SERVICE INFORMATION LETTER

ALT-8000 transmit and receive antenna coupler assembly Aeroflex part number 88590.

Figure 1

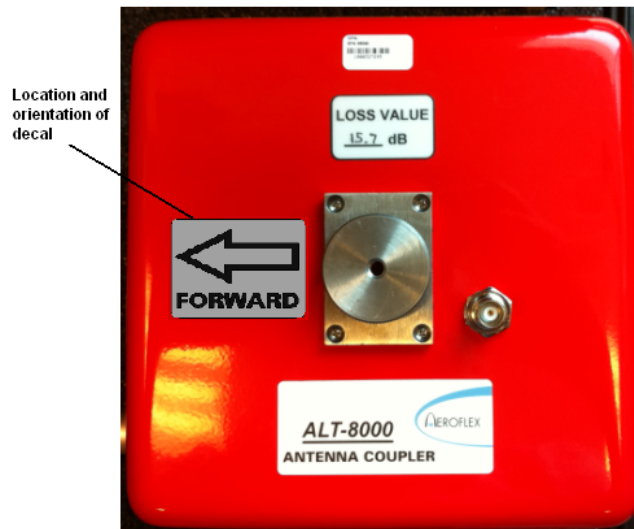
Aeroflex has identified the need to orient the transmit and receive antenna couplers (supplied with the ALT-8000 test system Aeroflex part number 84340) with the installed direction of the aircraft radio altimeter antennas . To assist the operator in properly orienting the couplers while testing a radio altimeter system on the aircraft, we have made the following decals available to the customers for the purpose of identifying the forward facing direction on the antenna couplers.

- 1) Orient the antenna coupler per figure 1.
- 2) Apply the decal to the antenna coupler per figure 1.
